7. Lease Name or Unit Agreement Name
 Quincy AMQ State

8. Well Number
 #3

SUNDRY NOTICES AND REPORTS ON WELLS
 (DO NOT USE THIS FORM FOR PROPOSALS TO DRILL OR TO DEEPEN OR PLUG BACK TO A DIFFERENT RESERVOIR. USE "APPLICATION FOR PERMIT" (FORM C-101) FOR SUCH PROPOSALS.)

Plan to plug and abandon the well as follows:

WELLBORE DIAGRAM

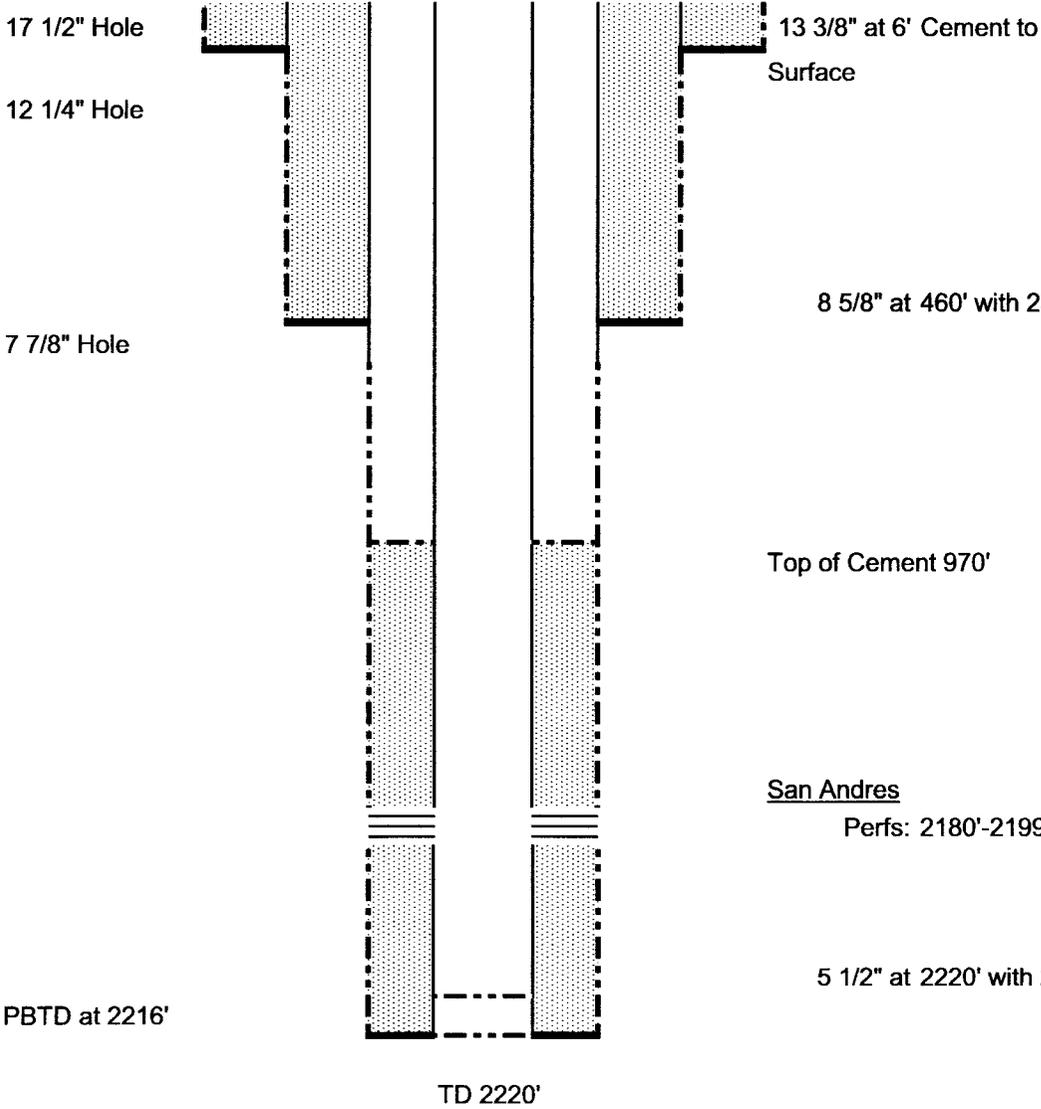
- MIRU. Set cement tanks. Pull rods, pump and tubing.
- Set CIBP at 2100' with 35' cement cap. ← *WOC & TAG*
- Circulate hole with +/- 25 barrels 10# brine and 12.5 ppb salt water gel.
- Perforate 4 squeeze holes at 500'. → *ADD A PLUG @ 820' TO 720' - (700')*
- Pump 135 sacks cement for solid cement plug inside and outside 5 1/2" casing from 500' to surface.
- Set Dry Hole Marker.
- Clean and remediate location.
